Office Action Summary	Application No. 10/633,958	Applicant(s) CHI ET AL.	
	Examiner Marissa L. Ferguson-Samreth	Art Unit 2854

DETAILED ACTION

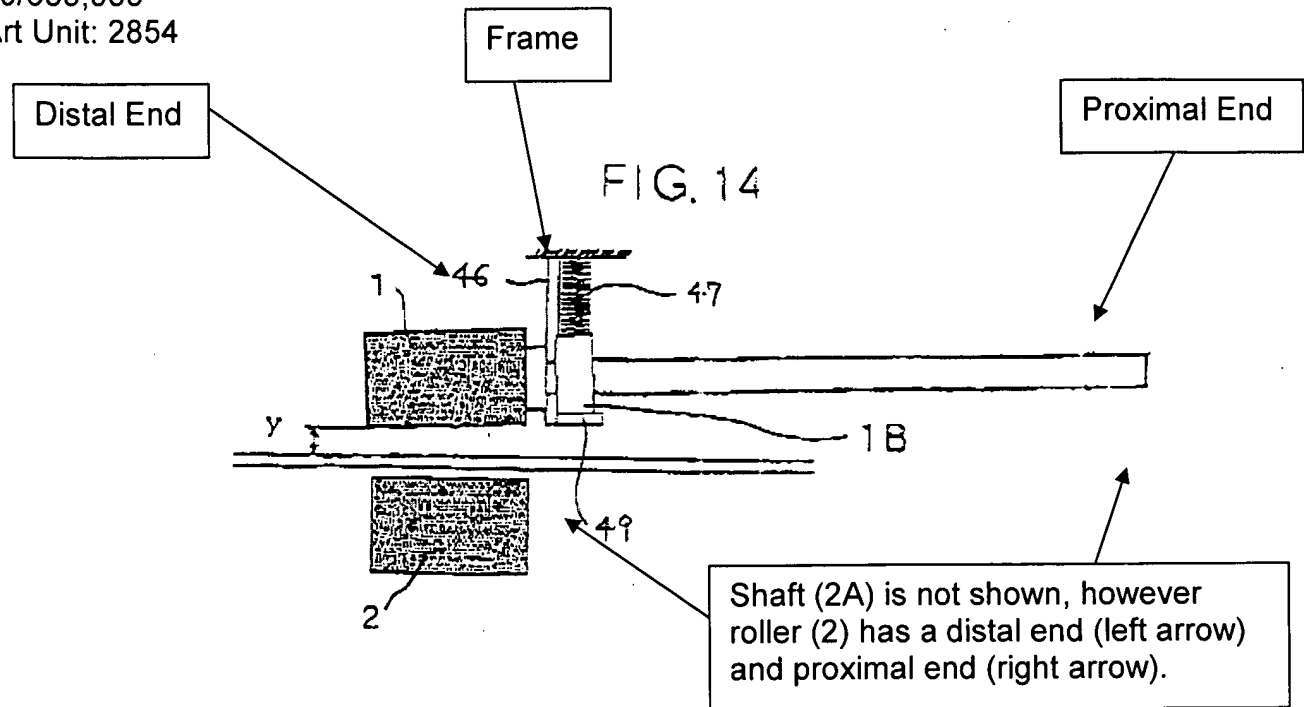
Regarding claims 1, 10, 20, 32, 40, 41, Miki teaches a method and apparatus comprising a frame (10), at least one cantilevered roller shaft (1A) comprises a distal end and a proximal end (refer to figure on page 4 of the detailed action) for advancing a document (P1,P2), wherein the proximal end is coupled to the frame of such that the distal end floats [As for advancing a document, wherein the at least one cantilevered roller shaft is supported only at one end (Figures 12-14)], a bearing (1B) coupled to the at least one cantilevered roller shaft (Figures 12-14) and a spring (47) coupled to the frame (10 and Figure on page 4 of the detailed action) and the bearing (1B) such that the at least one cantilevered roller shaft is spring loaded against a drive roller shaft.

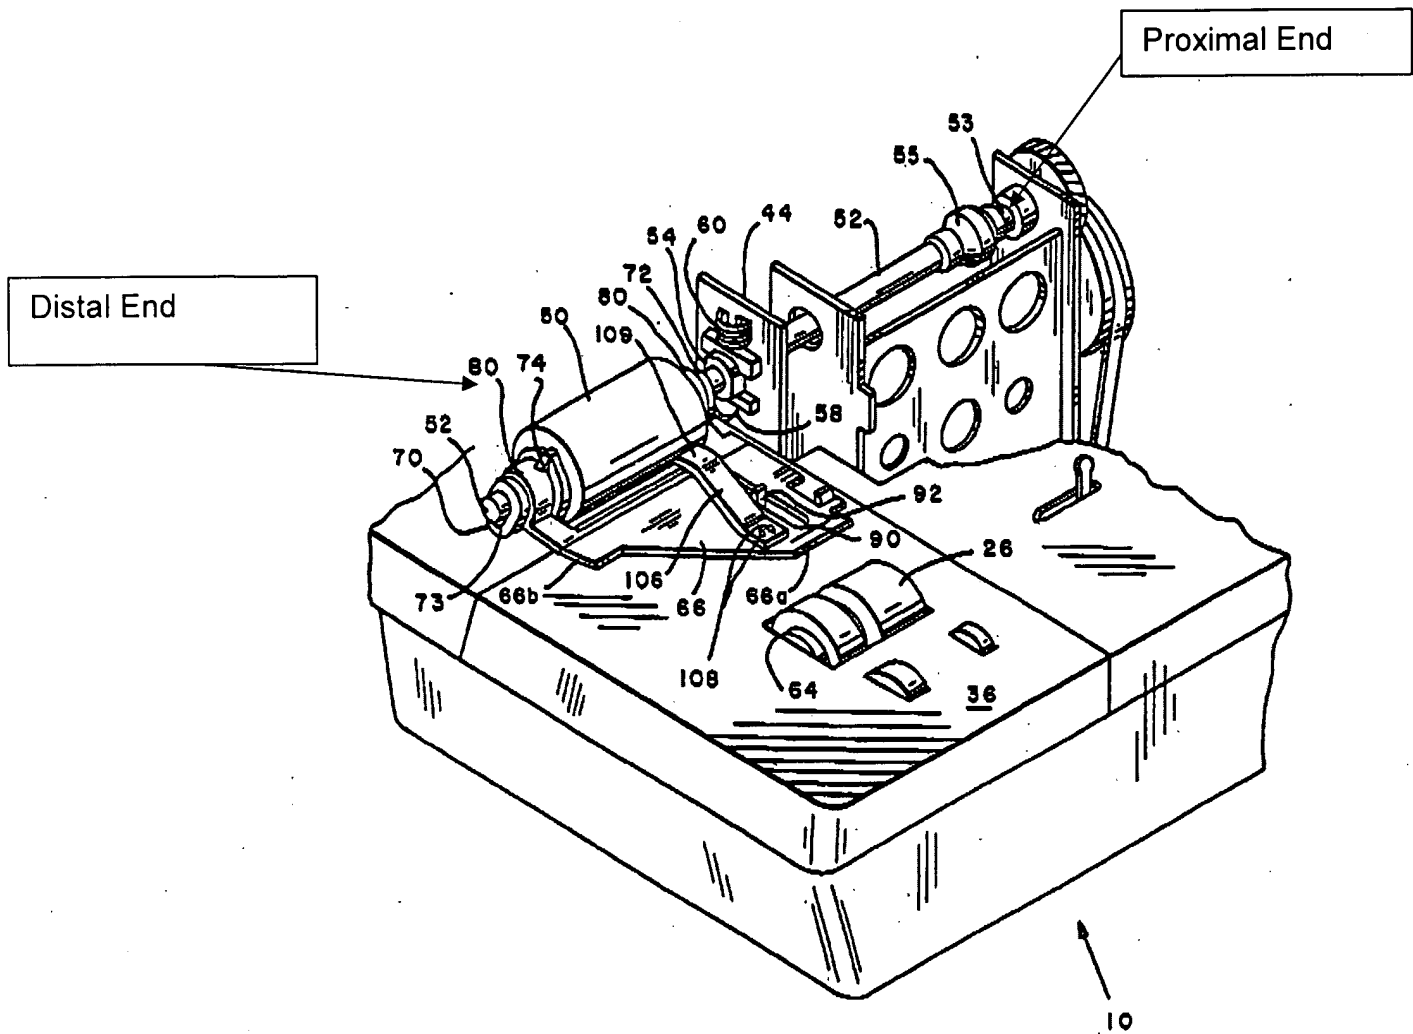
Regarding claims 1, 10, 20, 32 and 40, Miciukiewicz teaches a method and apparatus comprising a frame (10, 12), at least one cantilevered roller shaft (52) comprises a distal end and a proximal end (refer to figure on page 3) for advancing a document (18), wherein the proximal end is coupled to the frame of such that the distal end floats, wherein the at least one cantilevered roller shaft is supported only at one end (Figure 2), a bushing/bushings (70, 72) coupled to the at least one cantilevered roller shaft and a spring (106) . However, he does not explicitly disclose a spring coupled to the frame and the bearing such that the at least one cantilevered roller shaft is spring loaded against a drive roller shaft. Miki teaches a spring (47) coupled to the frame (10 and Figure on page 4 of the detailed action) and the bearing (1B) such that the at least one cantilevered roller shaft is spring loaded against a drive roller shaft.

FIG. 1

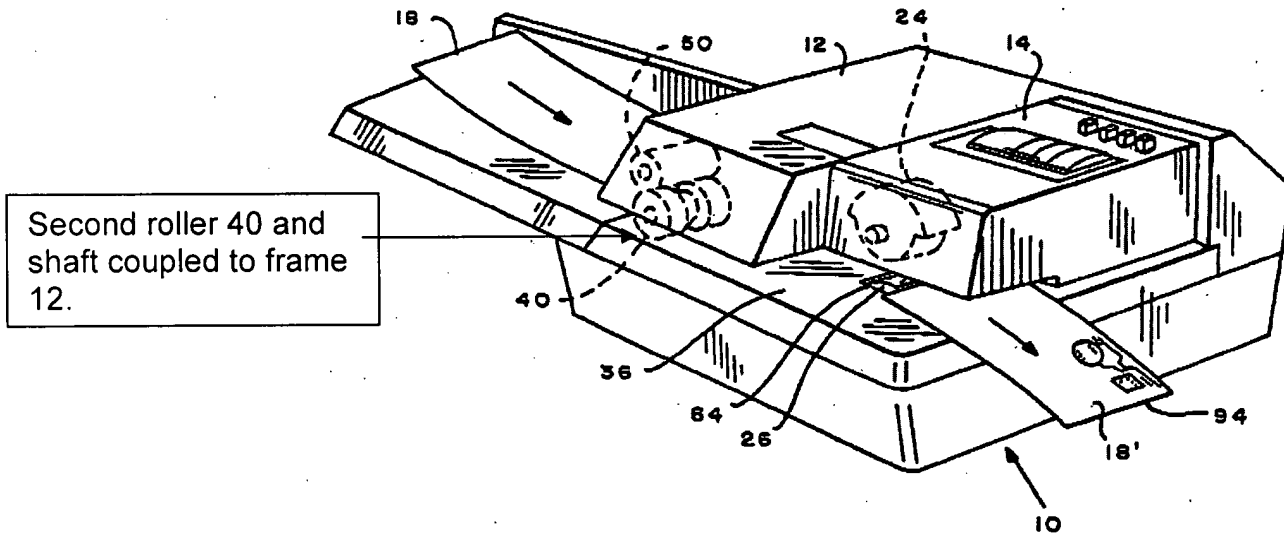
Regarding claim 15, 26, 35, 36, 37 and 43, Miciukiewicz teaches a method and apparatus comprising, a second roller shaft coupled to the frame (refer to figure 4 on page 5 and figure 1 below) for advancing a document, a second roller shaft having a distal and proximal end (refer to figure 8 on page 5), wherein the distal end floats and wherein the document is removed from the path (note: this is an obvious feature).

Regarding claims 18, 29, 44 and 45, Miciukiewicz teaches a method and apparatus comprising wherein the frame further comprises a main portion (12) and front portion (10), and wherein the second roller shaft (refer to figure 1 on page 4 and figure 4 on page 5) is coupled to the main portion such that the second roller shaft does not rely on the front portion for support.

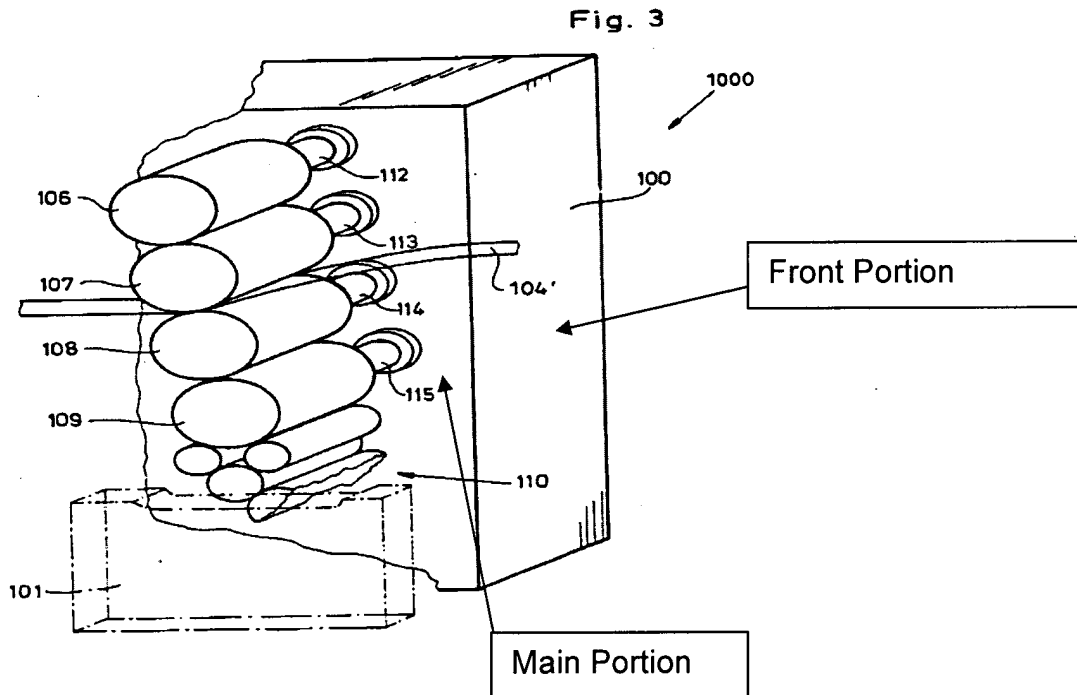
Regarding claims 4, 13, 23, Guaraldi teaches a method and apparatus wherein a frame (100) further comprises a main portion and front portion (refer to figure 3 below), and wherein the at least one cantilevered roller shaft (113) is coupled to the main portion such that the at least one cantilevered roller shaft does not rely on the front portion for support (Figure 3).

Regarding claims 18, 29, 44 and 45, Guaraldi teaches a method and apparatus comprising wherein a frame (100) further comprises a main portion and front portion (refer to figure 3 on page 3 of the office action), and wherein the second roller shaft (114) is coupled to the main portion such that the second roller shaft does not rely on the front portion for support (Figure 3).
